Access Compliance Report

Public Rights-of-Way

Intersection ID: 28157	Main Street: LANDEN_DR	Cross Street: LONGMONT_DR	Location: NE
ADA ID: 2979E384F3A4	Ramp Type: BlendTrans1	Initial Pass/Fail: Fail	Overall Compliance: No
		Severity Score: 8.75

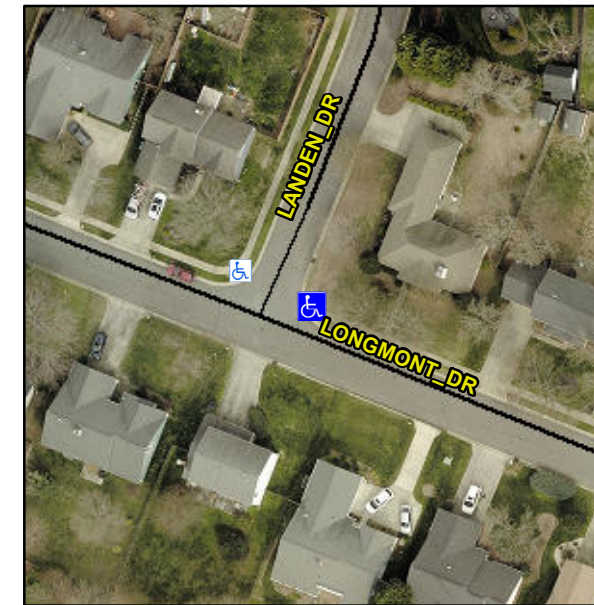
Not Found, R304.5.1

Compliance	Description	Data	Compliance	Description	Data
N/A	Ramp Length (in)	88.0	Yes	BlendTrans Slope (%)	4.5
No	Ramp Width (in)	39.0	Yes	BlendTrans XSlope (%)	1.2
N/A	Flare Type LT	N/A	N/A	Flare Type RT	N/A
N/A	Flare Slope LT (%)	N/A	N/A	Flare Slope RT (%)	N/A
N/A	Flare Traversable LT?	N/A	N/A	Flare Traversable RT?	N/A
N/A	Landing Length (in)	N/A	N/A	DWS Provided?	N/A
N/A	Landing Width (in)	N/A	N/A	DWS Contrast?	N/A
N/A	Landing Slope (%)	N/A	N/A	DWS Length (in)	N/A
N/A	Landing X Slope (%)	N/A	N/A	DWS Full Width?	N/A
N/A	Landing Curb? (Y/N)	N/A	N/A	DWS Offset (in)	N/A
N/A	Shared Landing?	N/A			
N/A	Gutter Ponding?	N/A	N/A	Gutter Slope (%)	N/A
N/A	Gutter Lip Ht (in)	1.0	N/A	Gutter X Slope (%)	N/A
N/A	Painted X Walk1?	No	N/A	Painted X Walk2?	No
	X Walk 1 Direction	To NW		X Walk 2 Direction	To SW
	X Walk 1 Width (in)	N/A		X Walk 2 Width (in)	N/A
	X Walk 1 Slope (%)	1.5		X Walk 2 Slope (%)	3.3
	X Walk 1 X Slope (%)	2.7		X Walk 2 X Slope (%)	0.2

N/A	Ramp inside XWalk1?	N/A	N/A	Ramp inside XWalk2?	N/A
	Road Slope (%)	0.4		Clear Space?	N/A
	Road X Slope (%)	3.7	N/A	Clear Space to XWalk (in)	N/A
N/A	Any Obstructions?	N/A	N/A	Storm Grate/Utility Hazard?	N/A
	Obstruction Type			Storm Grate/Utility Type	
		N/A			N/A
			Yes	Surface Condition? (G/P)	Good
			No	Curb Slope (%)	14.1

Remove & Replace Curb Ramp With Two New Directional Ramps or Equivalent.
